Oregon State University

HMC GENERATOR REPLACEMENT

PROJECT NUMBER: 2605-25C

ADDENDUM NO. 2

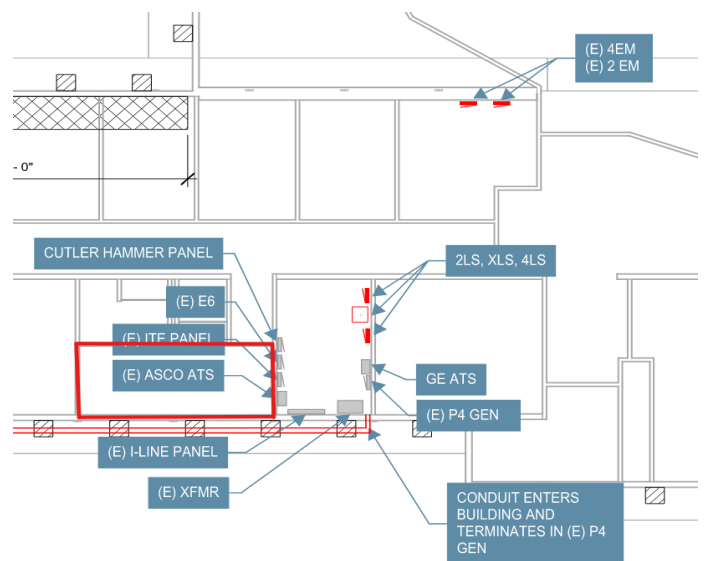
- Item 10 **Q:** Sheet E1.00 – Refer to area labeled “ABOVE ANIMAL HOSPITAL” – There is a note that states, RELOCATE CIRCUITS 4L-64,65 TO PANEL, but does not designate what panel to relocate to. Please clarify which emergency panel we are to relocate circuits 4L-64,65 to.
A: Relocate circuits to 4EM.
